PRODUCT/PROCESS CHANGE NOTICE (PCN)

PCN #: TB-0609-03	DATE: 06-Oct-2006	MEANS OF DISTINGUISHING CHANGED DEVICES:
Product Affected: All square PQFP and TQFP, MLP Dual, QFP-N, VFQFP-N packages shipped in Tape and Reel		☐ Product Mark ☐ Back Mark ☐ Date Code ☒ Other
Date Effective: 06-Nov-2006		Starting 06-Nov-2006

ATTACHMENT I - PCN #: TB-0609-03

PCN Type: To comply to current EIA Standard (EIA-481-C) requirement.

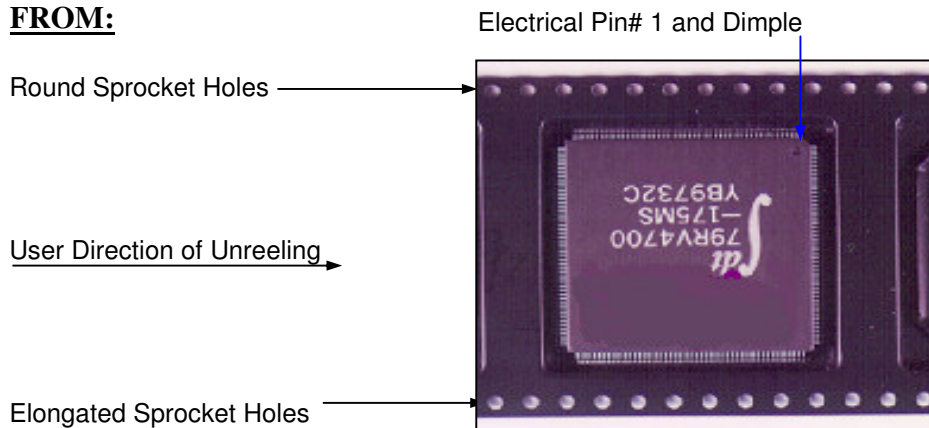
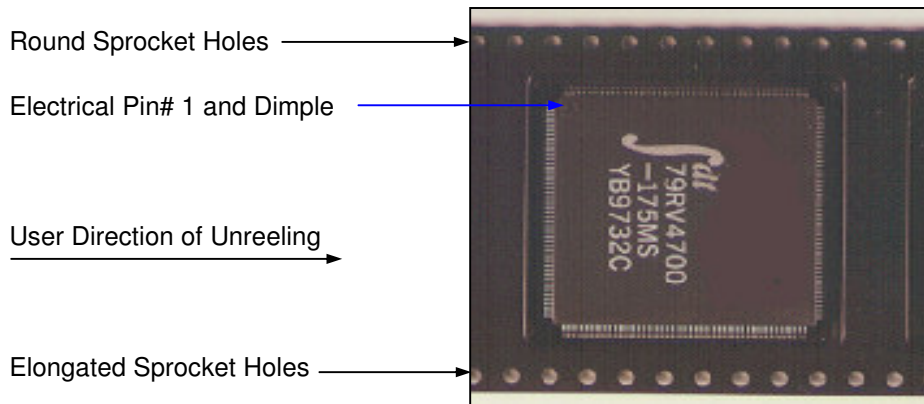
| ☐ Die Technology | Pin 1 orientation of all square PQFP and TQFP, MLP Dual, QFP-N and VFQFP-N packages shipped in Tape and Reel packaging will be changed to comply with current EIA Standard (EIA-481-C) requirement. |

Detail of Change: This change will be implemented on all square PQFP and TQFP, MLP Dual, QFP-N, VFQFP-N packages.

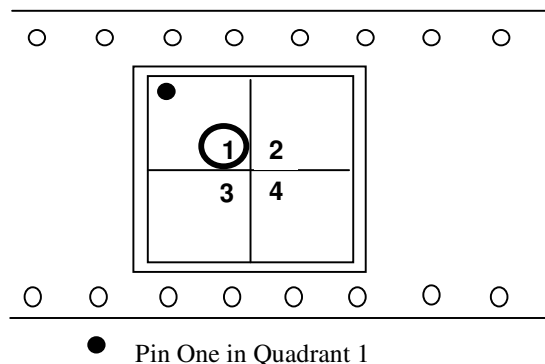
Additional label as shown below will be placed on the intermediate box (pizza box) to alert customer of this change. Label will be placed starting 06-Nov-2006 until 06-Nov-2007.
